Career Technical Education Building
Payette School District #371
915 S. Main Street
Payette ID 83661
Tenant Improvement

Clarification #1

The following additional information have been added to the attached sheets and clouded as clarification #1 and shall be incorporated into the project and project construction estimates:

2 BASE CABINET
SCALE 3/4" = 1'-0"

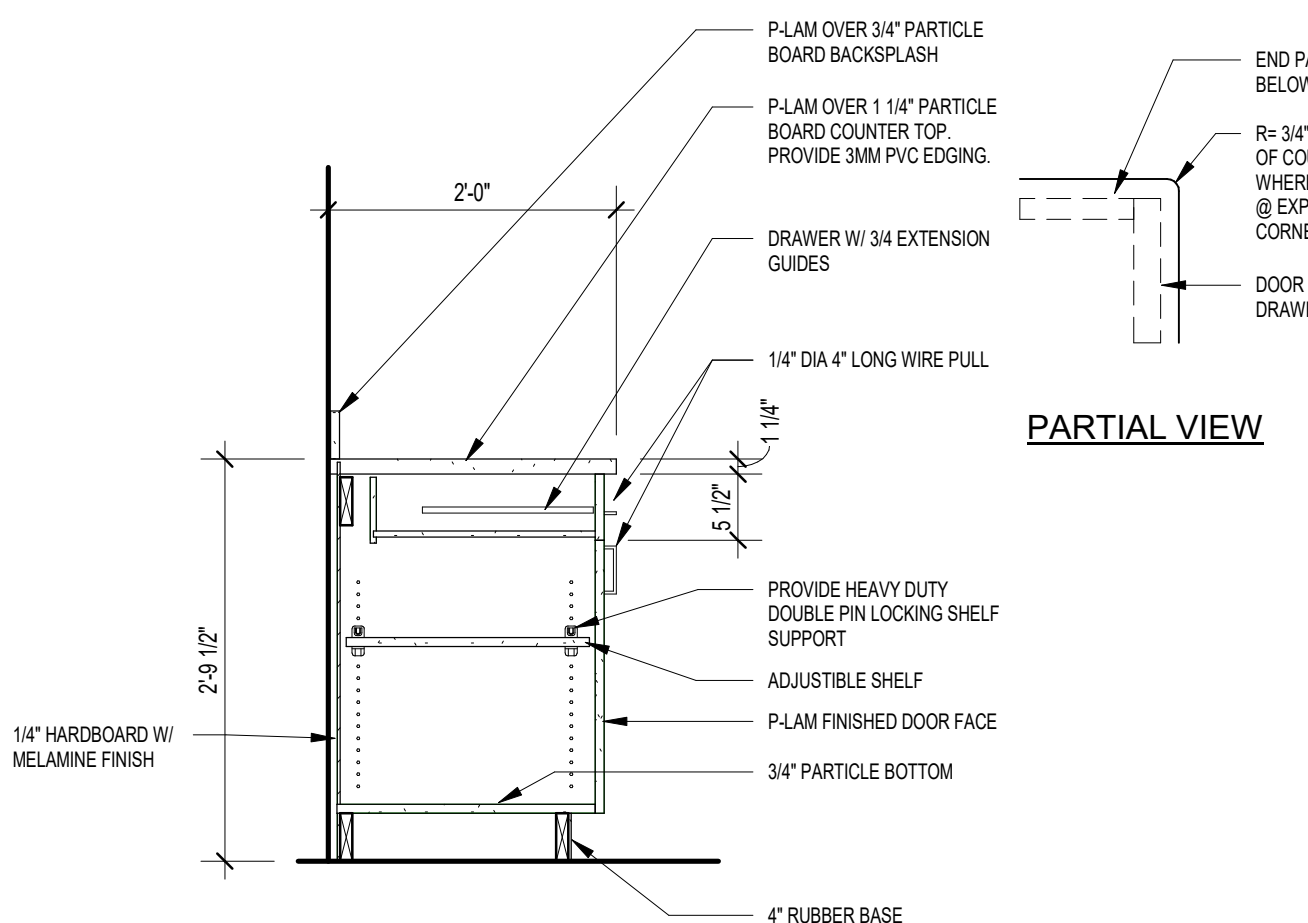
- Details 1 thru 4 – Clarified casework details
- Details 6 and 7 – Added information
- Added Details – 13 thru 18
